## Historic Architectural Review Commission Staff Report for Item 13

Address: #1319 Elizabeth Street

Conversion of a duplex, built in 1948, into a single-family home.

## PROPOSED ELEVATIONS

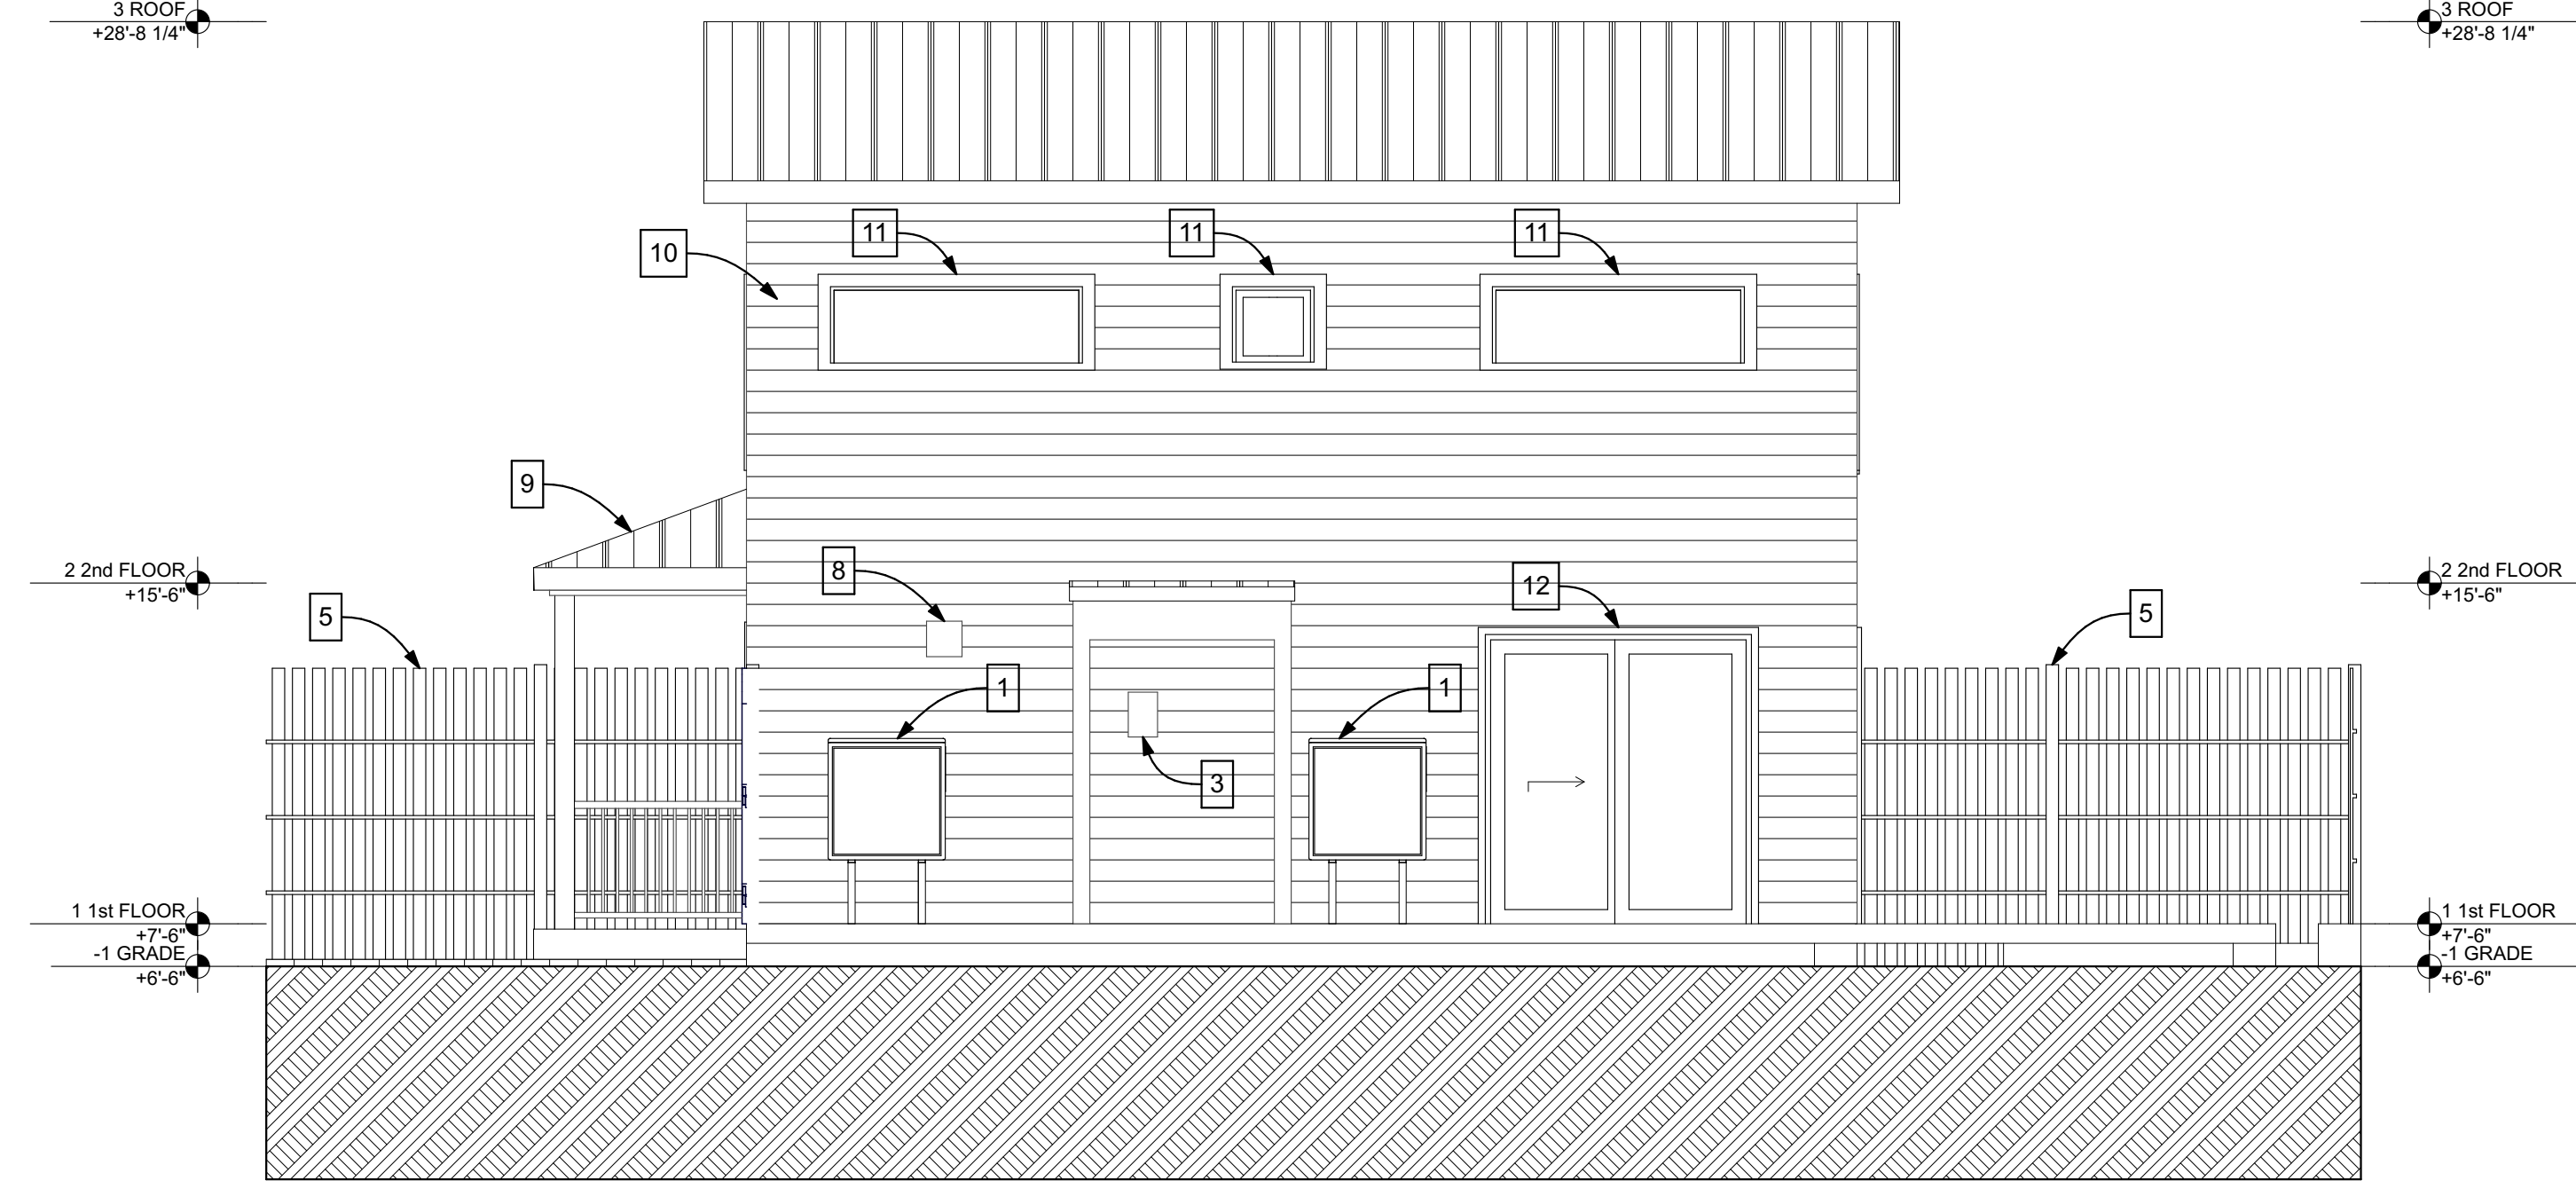
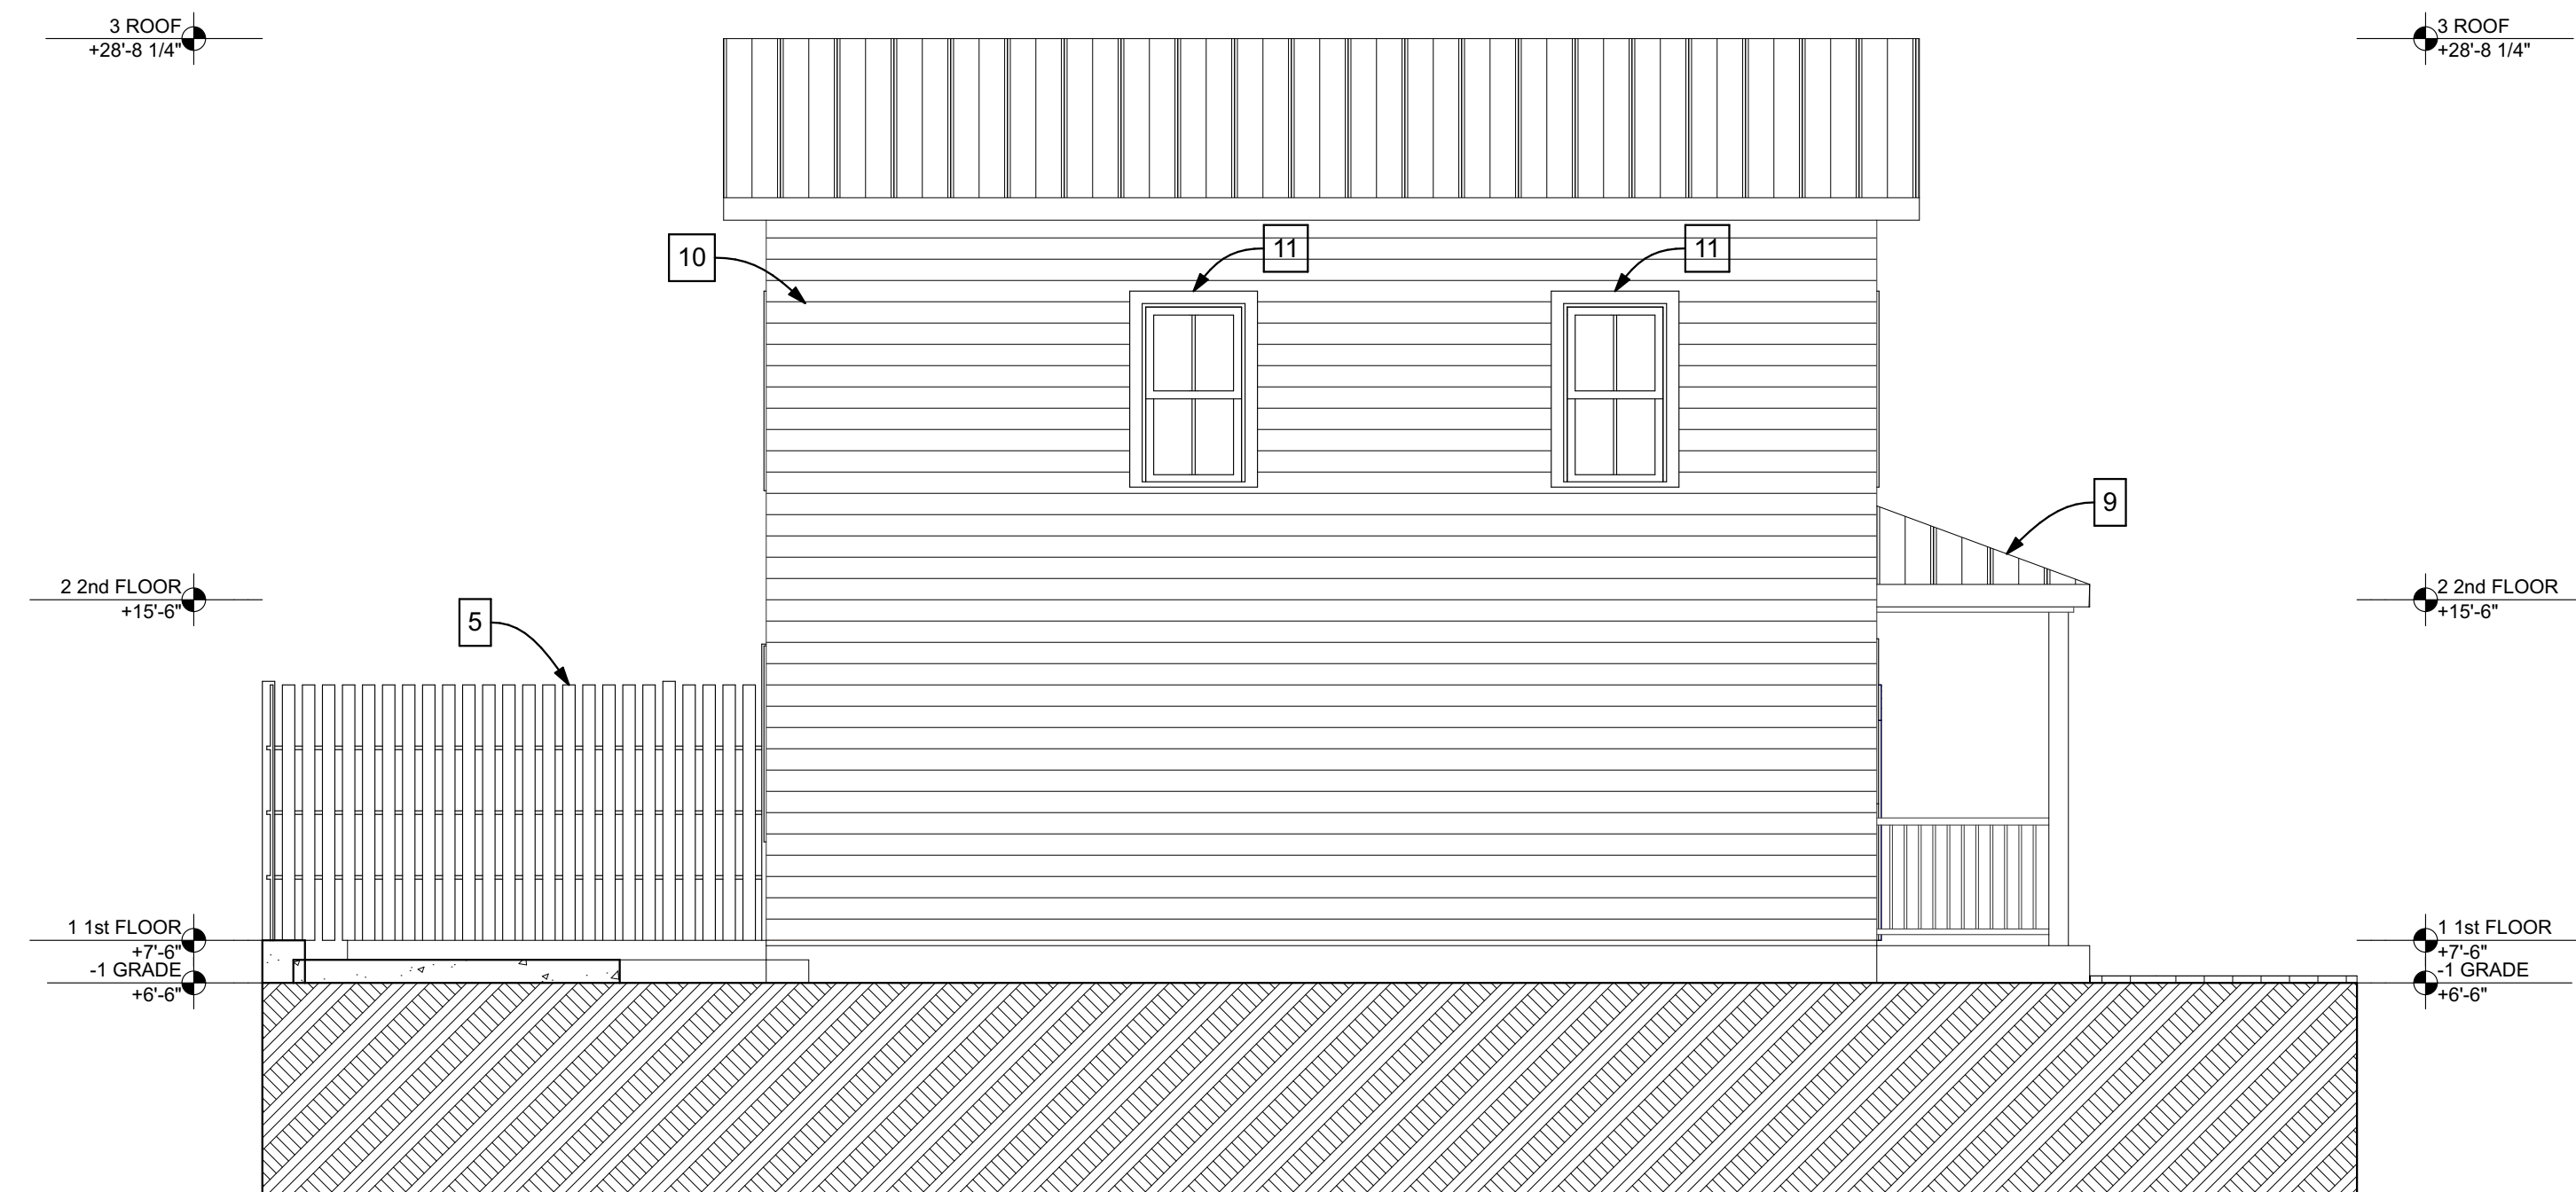
There is a mix of window types and materials throughout the structure. The only historic windows on the first floor are jalousies, and the remaining historic, 2-over-2 wood windows on the second floor have either deteriorated or been replaced by newer wood units. Due to 1319 Elizabeth being built circa 1948, and the intent of the new (not yet adopted) window guidelines to allow aluminum replacement windows on post-1945 structures, staff finds that the proposal to replace all windows with aluminum units would be appropriate, even though current guidelines would require that the replacements be wood. Staff finds no issue with the reconfiguration of the fenestration on any of the four elevations.

The proposed porch addition on the front elevation is in conflict with guideline 7 under *Additions and Alterations*, which states, “Additions proposed on the front of a contributing or historic structure are prohibited unless factual evidence for the building or structure in question proves the contrary.” However, while the pre-existence of a porch on this structure cannot be evidenced, staff opine that this proposal for a front porch on a contributing structure is appropriate to the building and to the streetscape. The front porch addition at 1319 Elizabeth will be compatible in scale and design with the building and will echo the front porches on other nearby historic buildings. The addition of the porch will also reinforce the pedestrian orientation on the streetscape, which is promoted by the guidelines, but is missing on this end of Elizabeth Street.
